Section 75W Modification Application 2 - Bodangora Wind Farm

Bodangora Wind Farm ("**Project**") is a proposed wind farm development located approximately 4 km north-east of Bodangora and 15 kilometres north-east of Wellington, in the recently formed Dubbo Regional Council.

Attachment C – Figure showing revised track layout

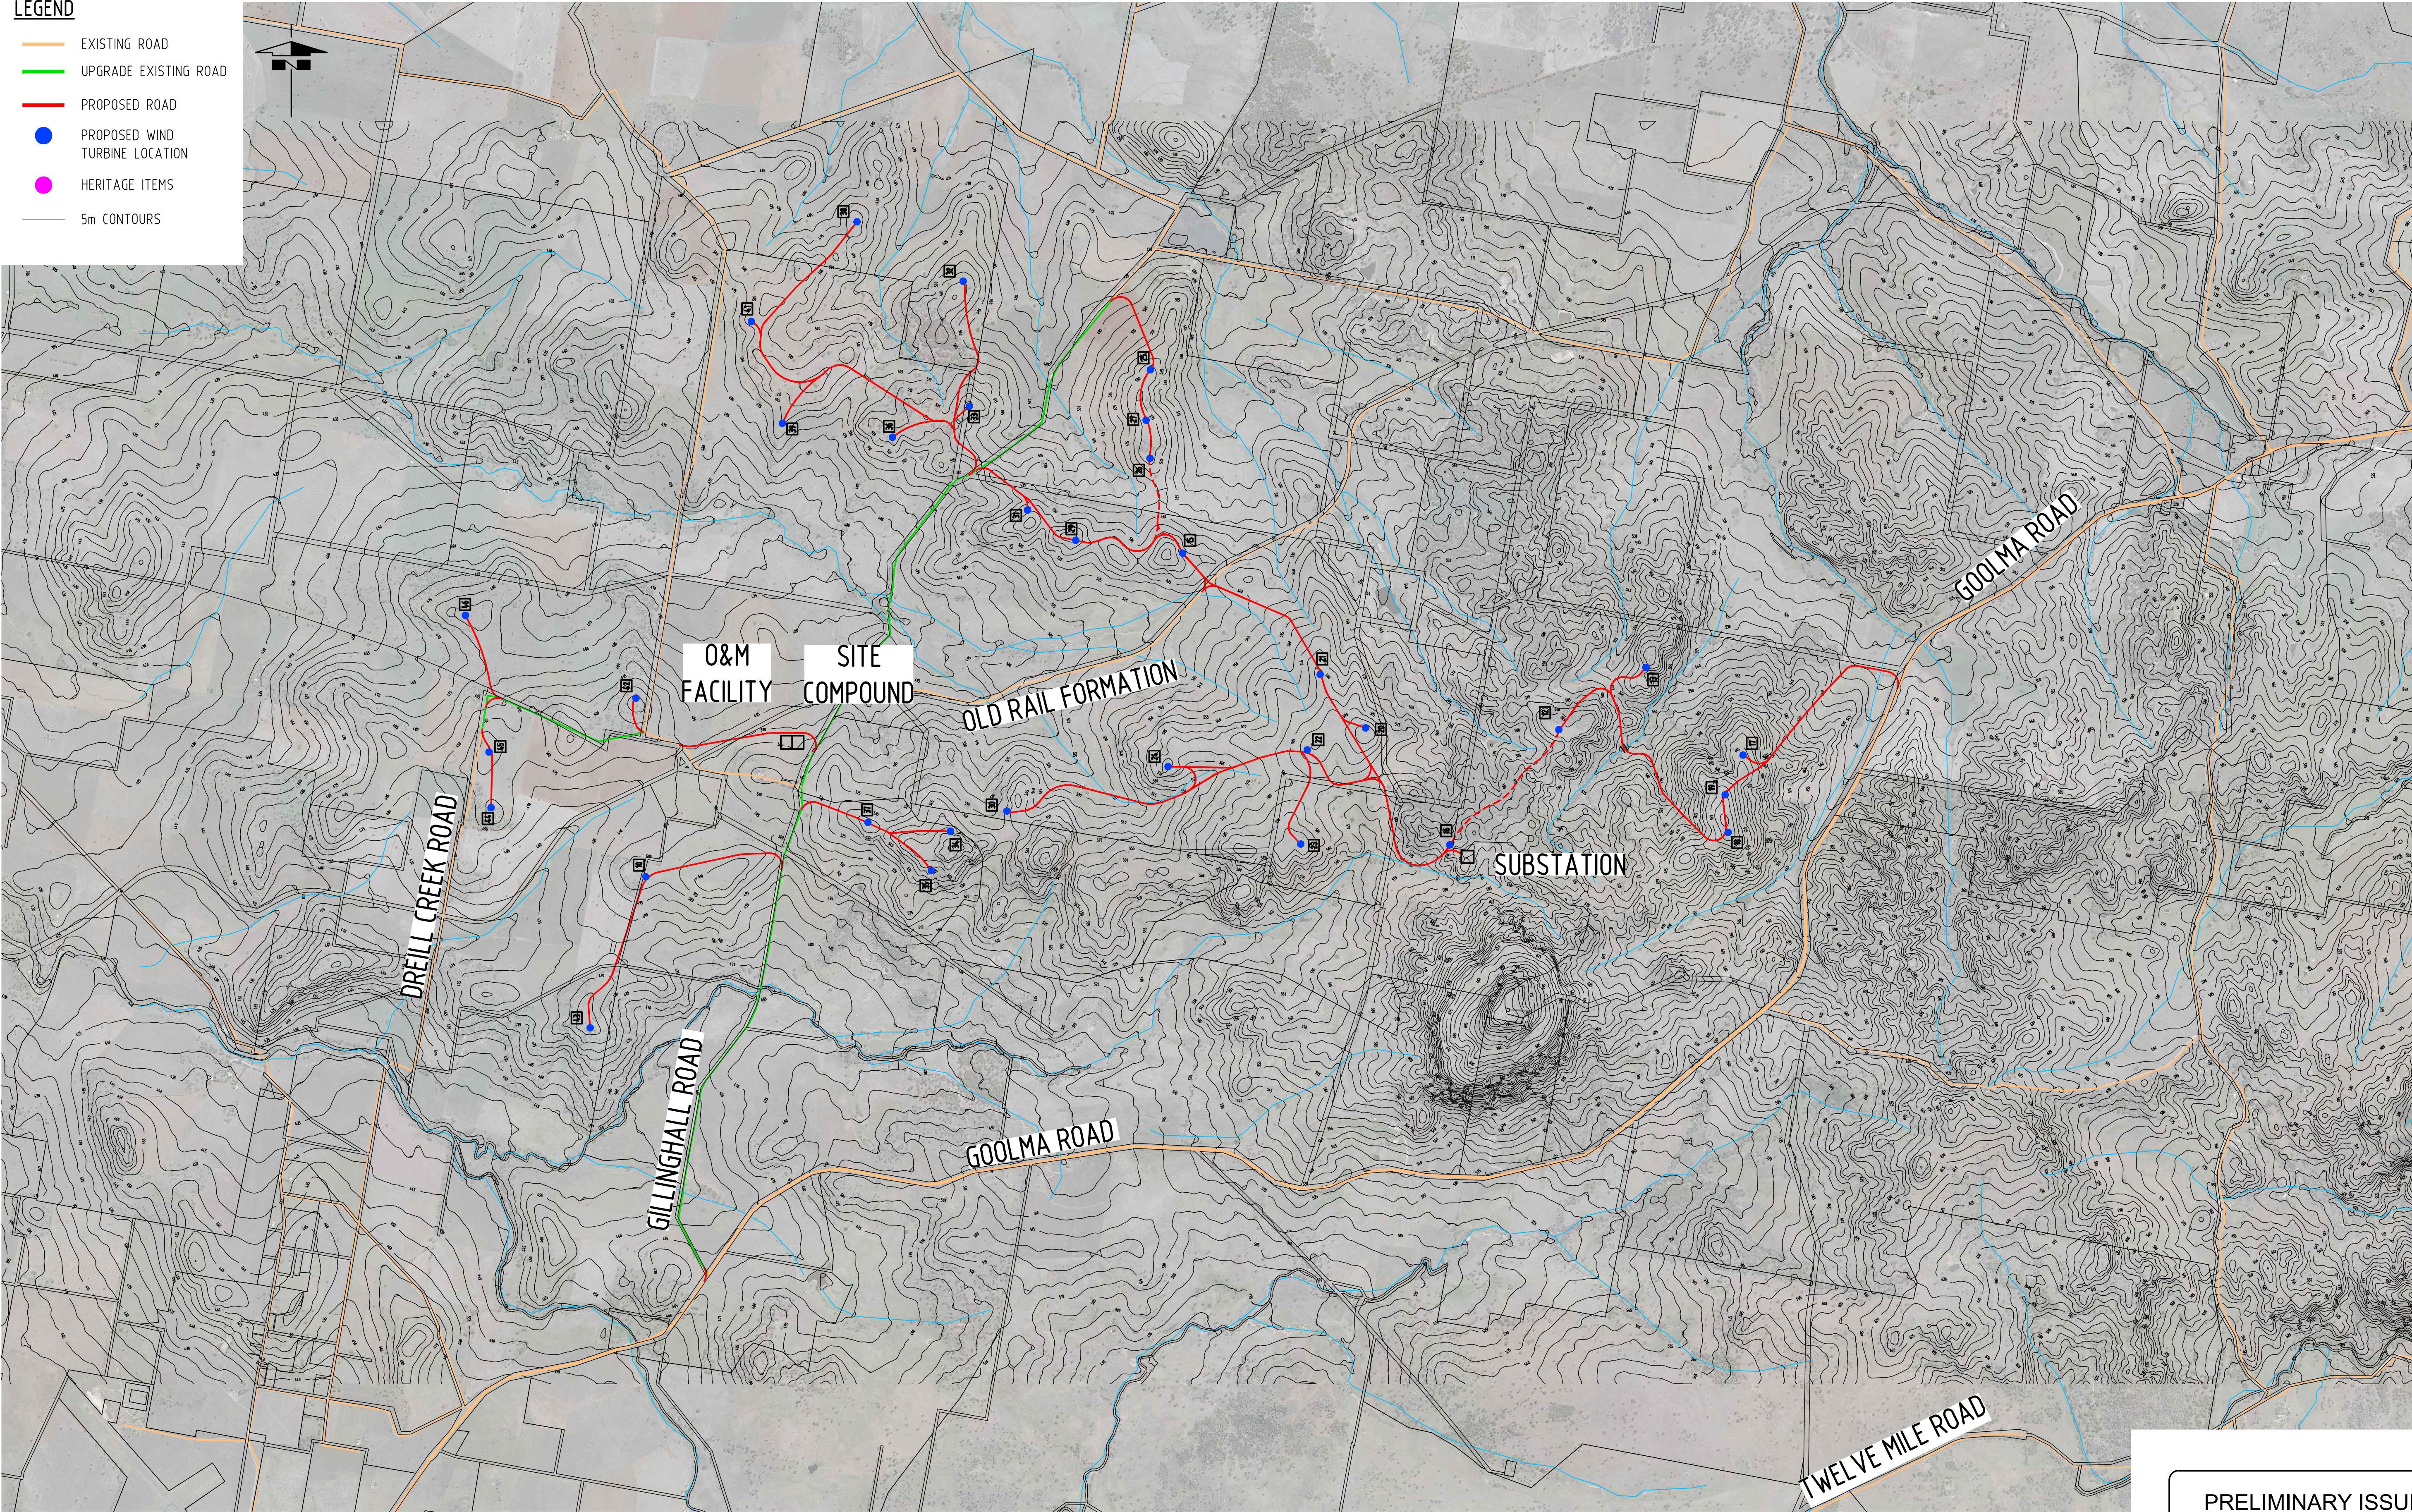
Following further detailed design work, a number of minor changes are proposed to the indicative access track layout shown in the Appendix A of the Preferred Project Report. The updated indicative access track layout proposed is shown on the map in **Attachment C**. The revised indicative access track and underground cable layout has been designed to:

- Removal of the optional access track between wind turbines 30 and 34;
- Consolidation and realignment of tracks between wind turbines 23, 24 and 30;
- Realignment of the track between wind turbine 18 and 12 and 13;
- Realignment of tracks between wind turbine 36, 39 and 41; and
- Realignment of the track between wind turbine 15 and 26.
